Final Rule, Response to Petitions for Reconsideration, Technical Amendment, Docket No. 2008-0111, Anthropomorphic Test Devices; ES-2re Side Impact Crash Test Dummy 50th Percentile Adult Male.

First Technology Safety Systems (FTSS) has reviewed the February, 2008, ES-2re dummy drawing package (identified in the above mentioned technical amendment) and we have identified a number of drawing errors and a number of drawing issues. We seek to petition NHTSA to correct these drawings to ensure that the ES-2re dummy continues to meet the same dimensional and performance requirements established for the dummy when the dummy was proposed for inclusion into 49 CFR Part 572 Subpart U. FTSS makes the following comments and recommendations with respect to the drawing package. A marked up drawing for each of these recommended changes are attached to the end of this letter.

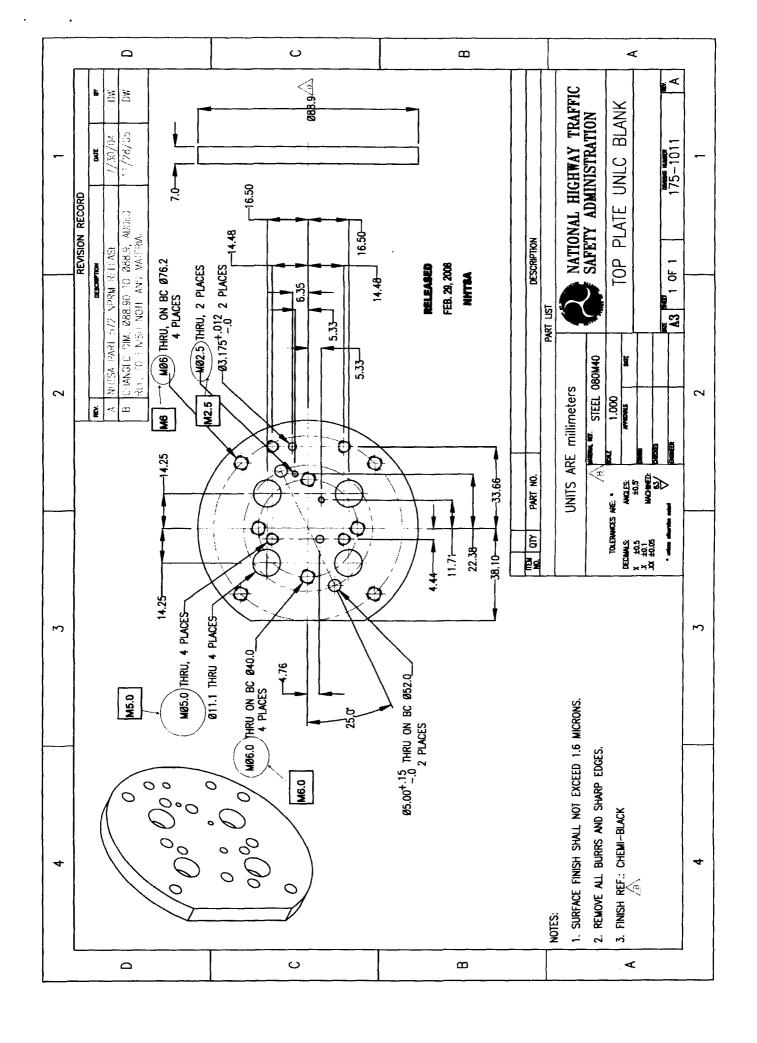
- Drawing 175-1011, Top Plate UNLC Blank. Fix typographical errors for dimensions, MØ5.0, MØ6.0, MØ6, and MØ2.5. Eliminate the Ø symbol.
- 2) Drawing 175-3502, Pivot Stop Plate, Left. Fix typographical error on Note #4. Replace RH with LH since this is a left hand part.

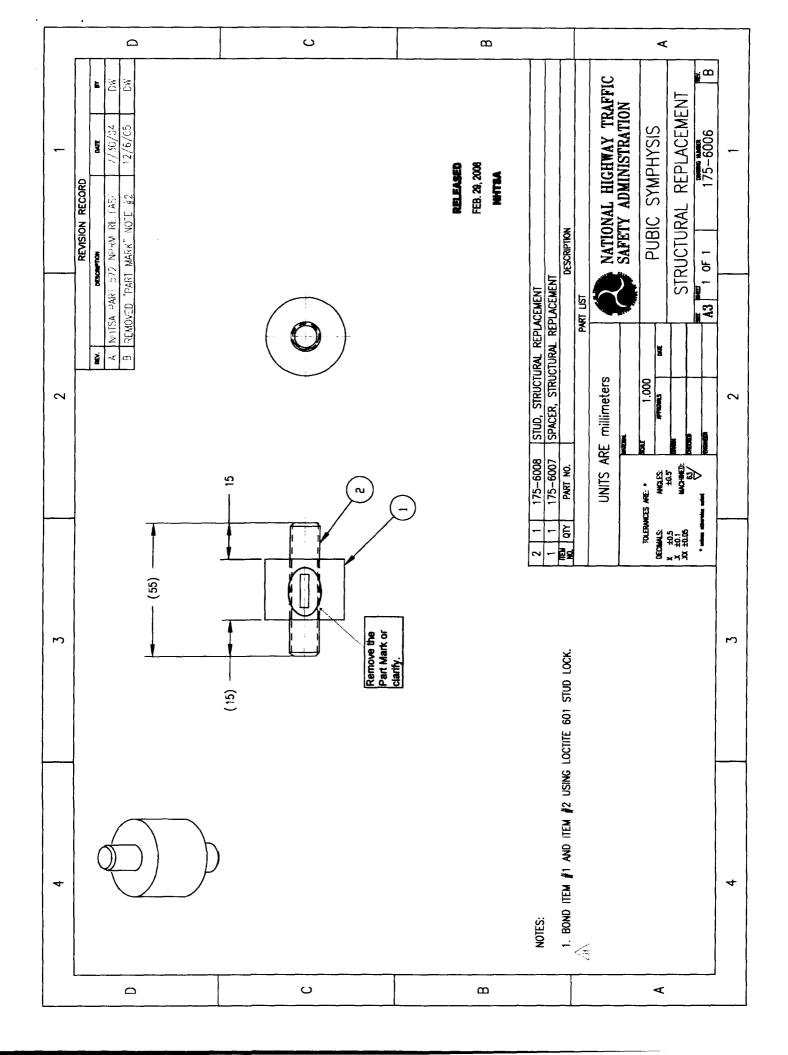
- 3) 175-6006, Pubic Symphysis Structural Replacement. There is a Part Mark located at the center of the part. This Part Mark is not defined. FTSS recommends that the Part Mark be clarified or removed altogether from the drawing.

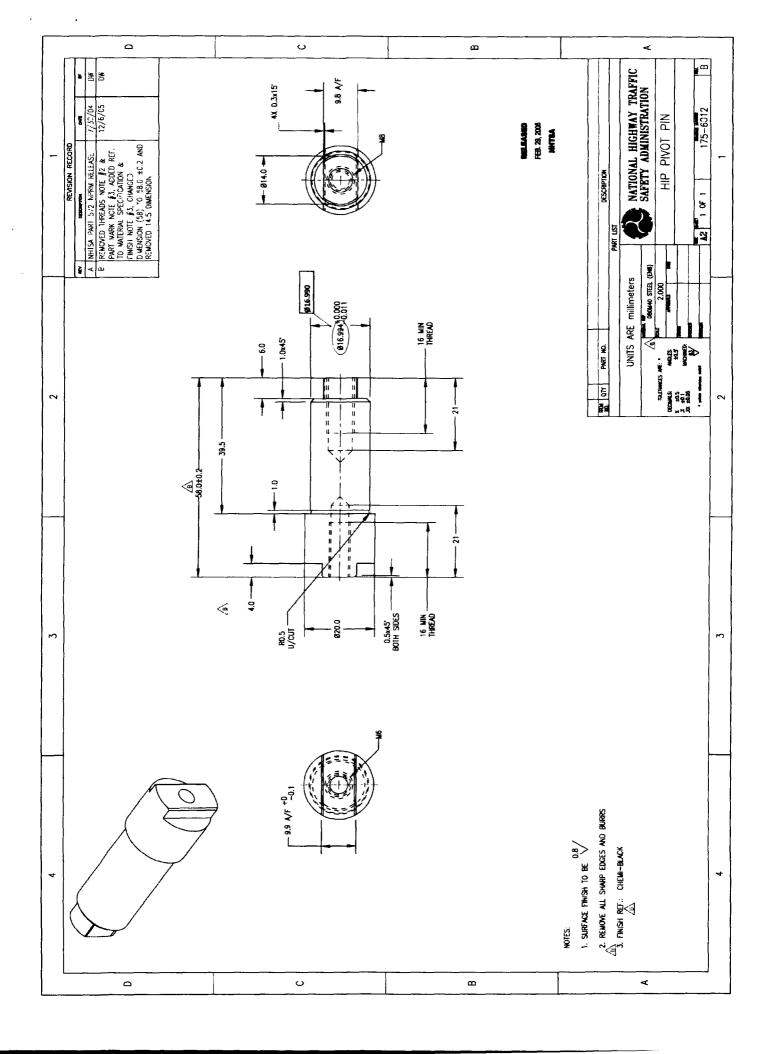
- 4) Drawing 175-6012, Hip Pivot Pin. FTSS believes that dimension "16.994 +0.000 / -0.011" is a typographical error and should be dimensioned as "16.990 +0.000 / -0.011". The Hip Pivot Pin mates to part number 5000110 (Ball Bearing) which has an ID dimension of 17.000 +0.000 / -0.008 (vendor specification). The bearing at a nominal dimension of 16.992 would not allow a Hip Pivot Pin at its maximum diameter of 16.994 to fit within the bearing.

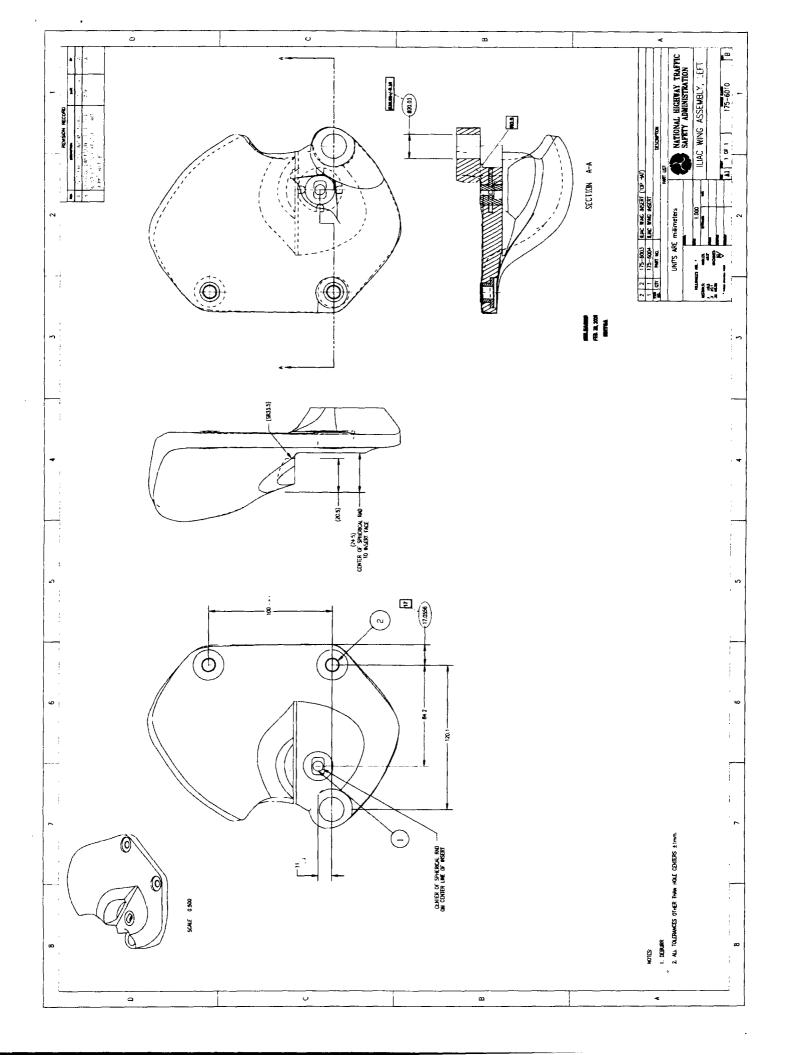
- 5) Drawing 175-6010, Iliac Wing Assembly, Left. Fix typographical error for drawing dimension "17.0556". This dimension should be "17" since it is not reasonable to control and measure this molded part to four decimal places and "17" also matches the same dimension as the Iliac Wing Assembly, Right (NHTSA Drawing 175-6002). FTSS also recommends that the drawing dimension "Ø20.03" be replaced with "Ø20.03 ± 0.10" since this dimension cannot be controlled to a tolerance of ± 0.05. We also recommend the addition of dimension "R0.5" to better define this location for easier machining of this particular section of the part and to prevent breakage due to concentrated stresses.

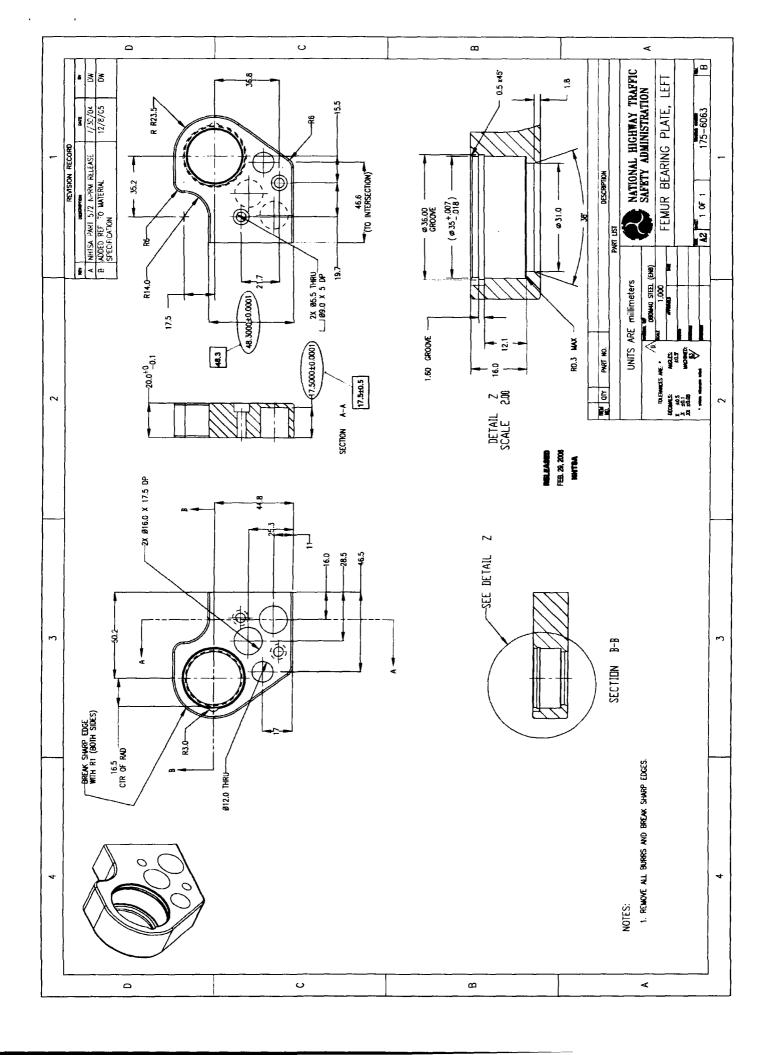
- 6) Drawing 175-6063, Femur Bearing Plate, Left. Fix typographical errors for drawing dimensions 17.5000 ± 0.0001" and "48.3000 ± 0.0001". The tolerances are too tight to reasonably achieve at four decimal places and would add unnecessary expense when making the part. FTSS recommends that these dimensions should be specified as "17.5 ± 0.5" and "48.3". These recommended dimensions would also match the existing dimensions on the Femur Bearing Plate, Right (NHTSA Drawing 175-6068).

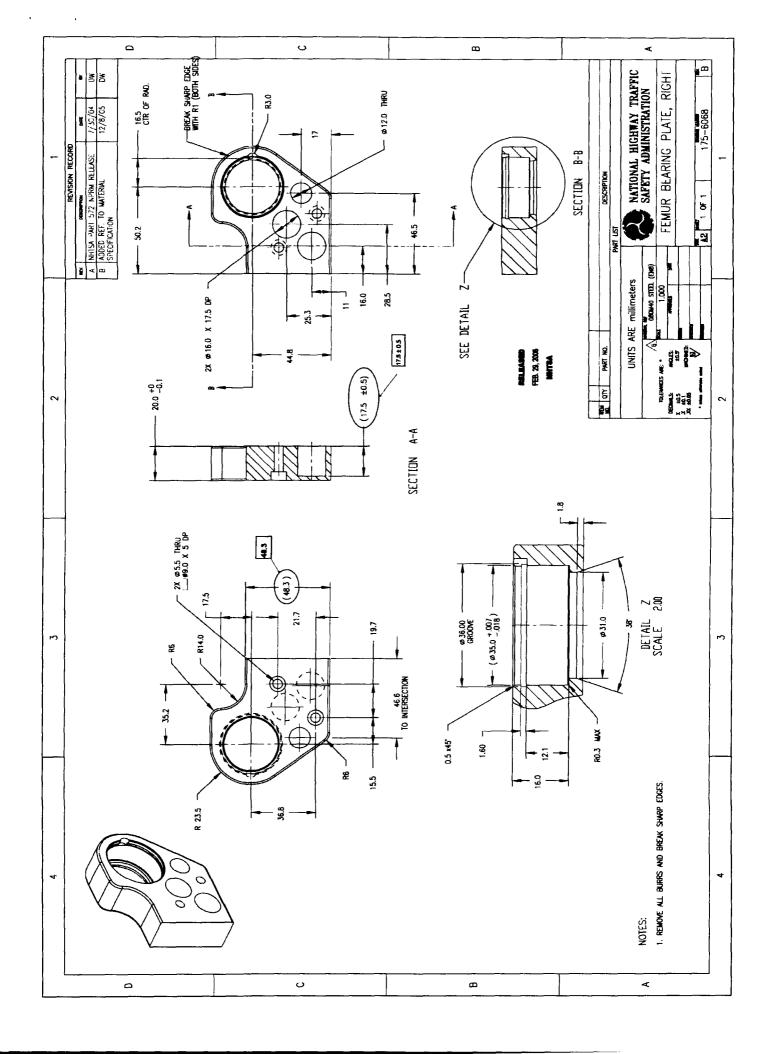
- 7) Drawing 175-6068, Femur Bearing Plate, Right. Fix typographical errors by removing the parenthesis from around dimensions "(48.3)" and "(17.5 ± 0.5)". This will maintain consistency between NHTSA Drawings 175-6068 and 175-6063.

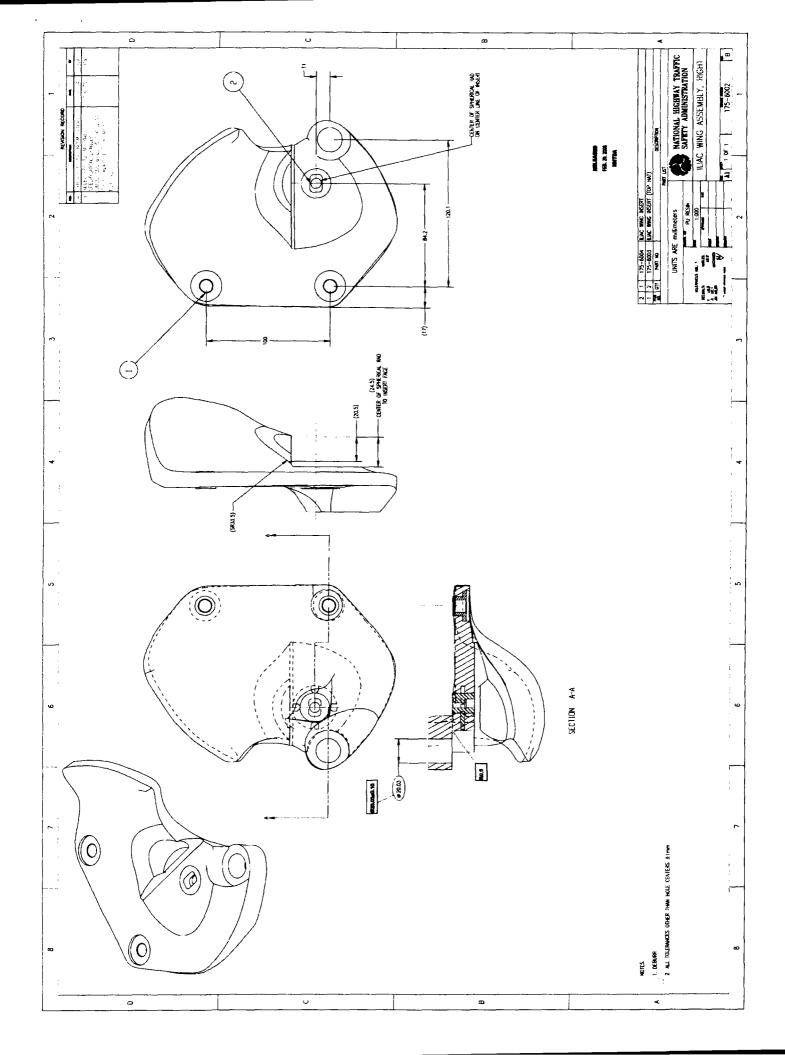
- 8) Drawing 175-6002, Iliac Wing Assembly, Right. FTSS recommends that the drawing dimension "Ø20.03" be replaced with "Ø20.03 ± 0.10" since this dimension cannot be controlled to ± 0.05. We also recommend the addition of dimension "R0.5" to better define this location for easier machining of this particular section of the part and to prevent breakage due to concentrated stresses.

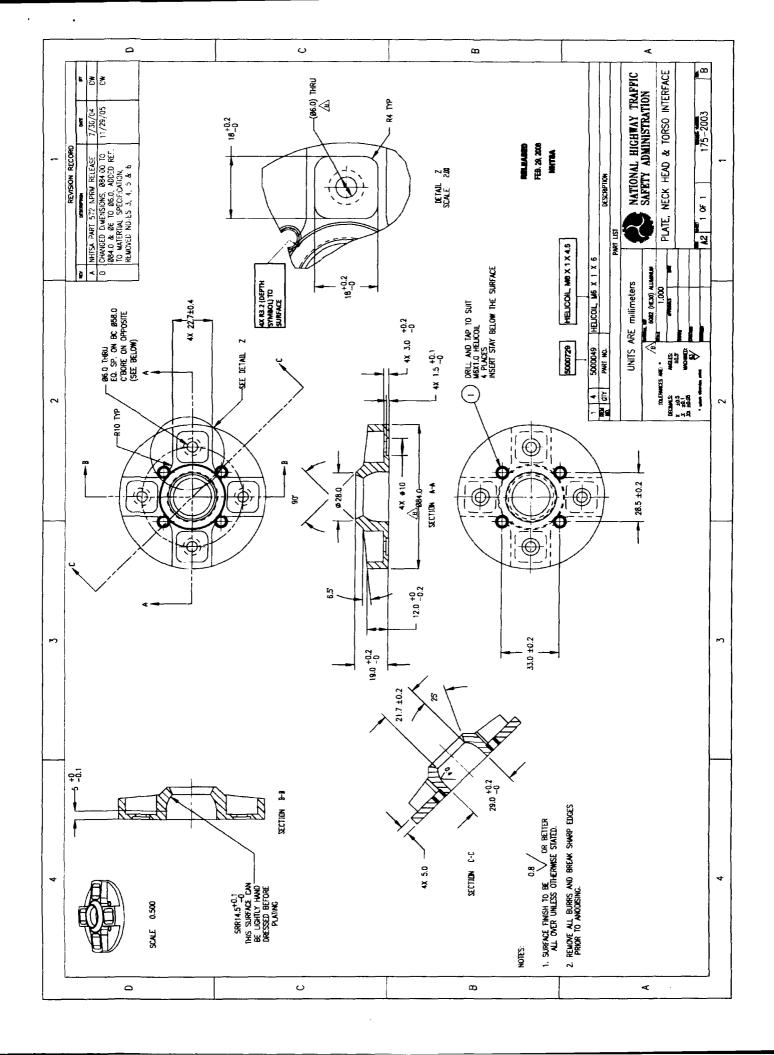
- 9) Drawing 175-2003, Plate, Neck Head & Torso Interface. FTSS recommends that NHTSA part number 5000049 Helicoil, M6 x 1 x 6, be replaced with part number 5000729 Helicoil M6 x 1 x 4.5 because the 5000049 Helicoil is too long and may not sit below the machined surface due to stack up tolerance of parts. FTSS also suggests the addition of dimension "4X R3.2 ** to the Surface" on Detail Z in order to clarify the dimension.

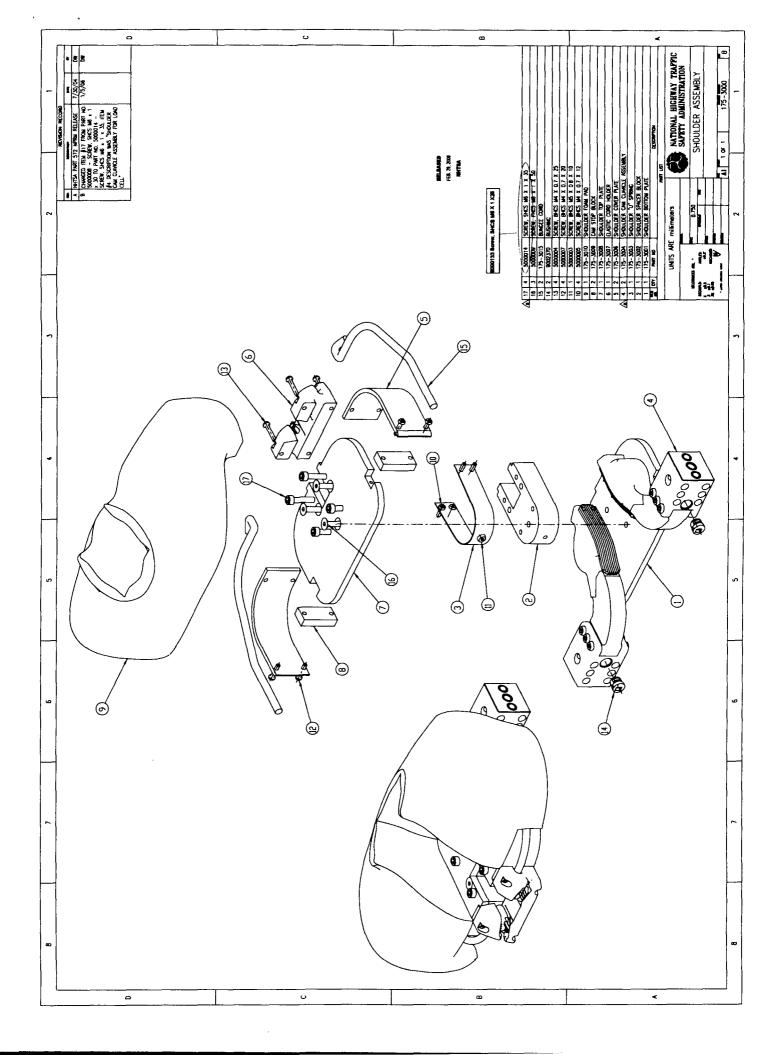
- 10) Drawing 175-3000, Shoulder Assembly. FTSS recommends that NHTSA part number 5000014 SHCS, M6 x 1 x 35, be replaced with part number 5000008 SHCS, M6 x 1 x 30 because the 5000014 SHCS is too long to properly secure the assembled parts. The M6 x 1 x 35 SHCS is supposed to secure the Shoulder Top Plate (175-3008) to the Shoulder Spacer Block (175-3002). However, the Shoulder Top Plate has a material thickness of 8 mm and the Shoulder Spacer Block has a material thickness of 25.5 mm. Together, the overall thickness of the combined parts is 33.5 mm which is 1.5 mm shallower than the length of the 35 mm long SHCS. This will create a condition where the 35 mm SHCS will not clamp the parts properly. A M6 x 1 x 30 SHCS will provide a 3.5 mm clearance to the bottom of the threaded holes on the Shoulder Spacer Block and is therefore an appropriate fastener for this application.

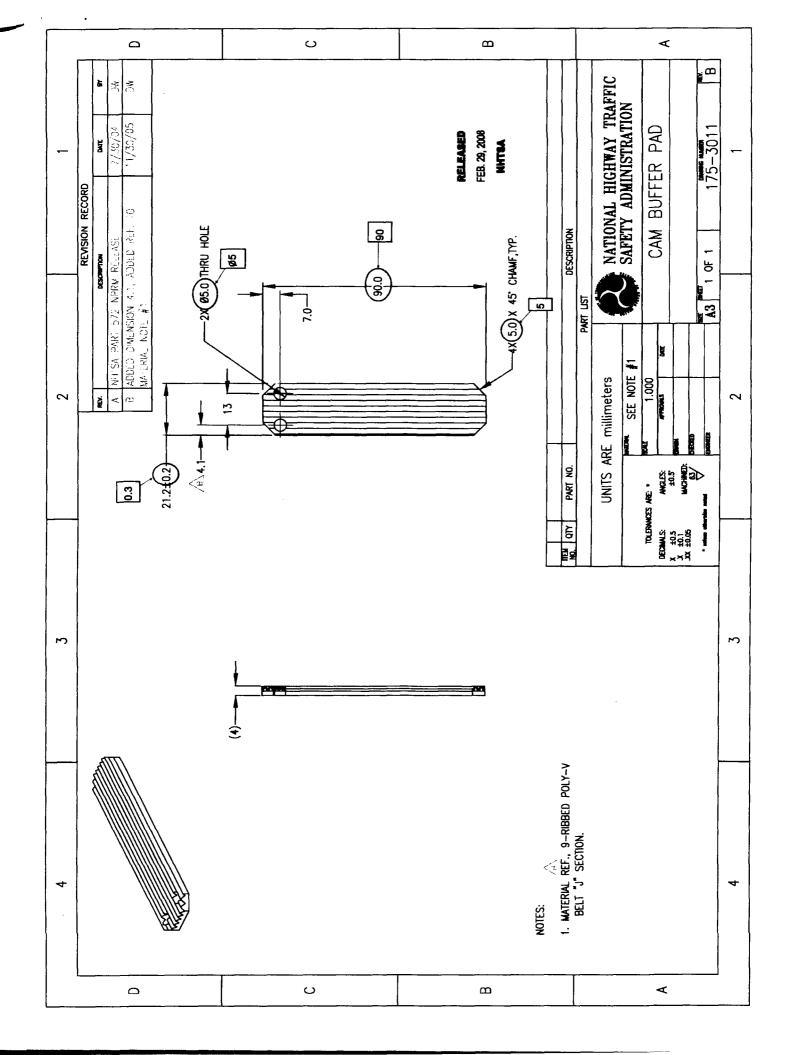
- 11) Drawing 175-3011, CAM Buffer Pad. FTSS has noted that the current dimensions for this part have tolerances that are too tight to accurately control a molded part. We recommend that the NHTSA drawing dimensions: " \emptyset 5.0", "90.0", "5.0", and "21.2 \pm 0.2" be replaced with these dimensions: " \emptyset 5", "90", "5", "21.2 \pm 0.3".

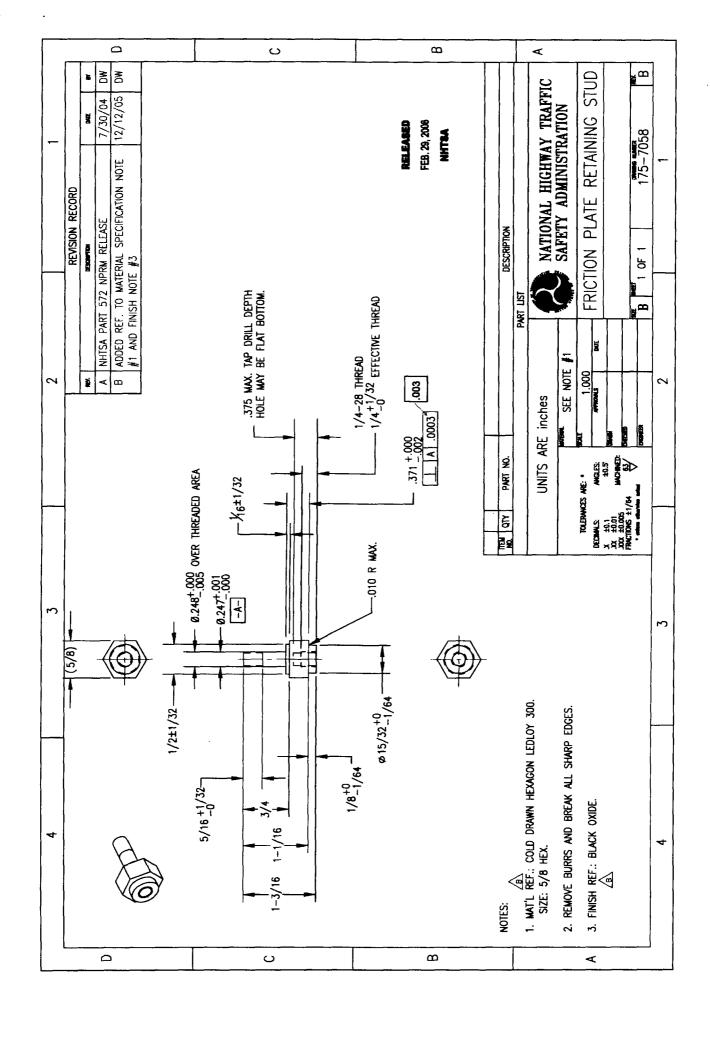
- 12) Drawing 175-7058, Friction Plate Retaining Stud. FTSS believes that the Datum A tolerance of ".0003" for the perpendicular surfaces is unnecessarily tight at four decimal places. We recommend a tolerance of ".003" because the NHTSA tolerance is too tight to be reasonably measured and therefore accurately controlled. Furthermore, at tolerance of ".0003" would add unnecessary cost to the part.

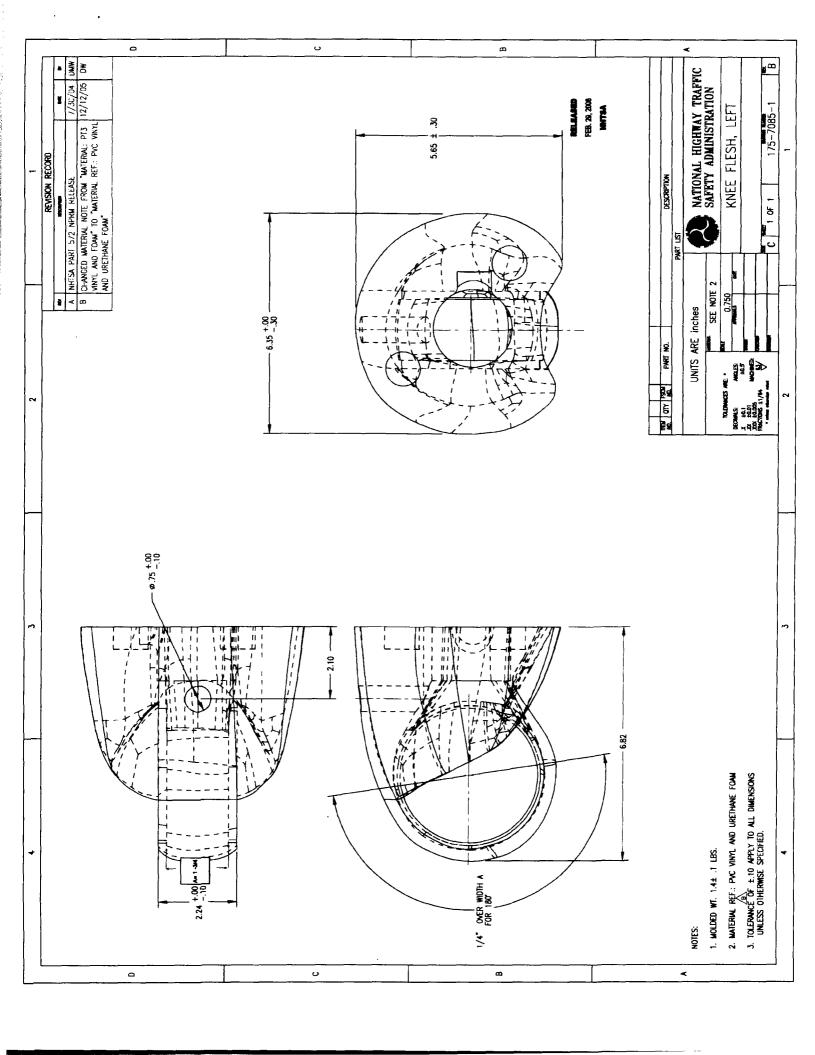
- 13) Drawing 175-7085-1, Knee Flesh, Left. There is a note on the drawing that states: $\frac{1}{4}$ " OVER WIDTH "A" FOR 180°. But, "A" is not defined on the drawing. However, "A" is defined on the corresponding drawing 175-7085-2, Knee Flesh, Right. FTSS recommends that drawing 175-7085-1 be corrected to add a definition for "A" to match drawing 175-7085-2 which specifies that "A = $1 \frac{3}{4}$ ".
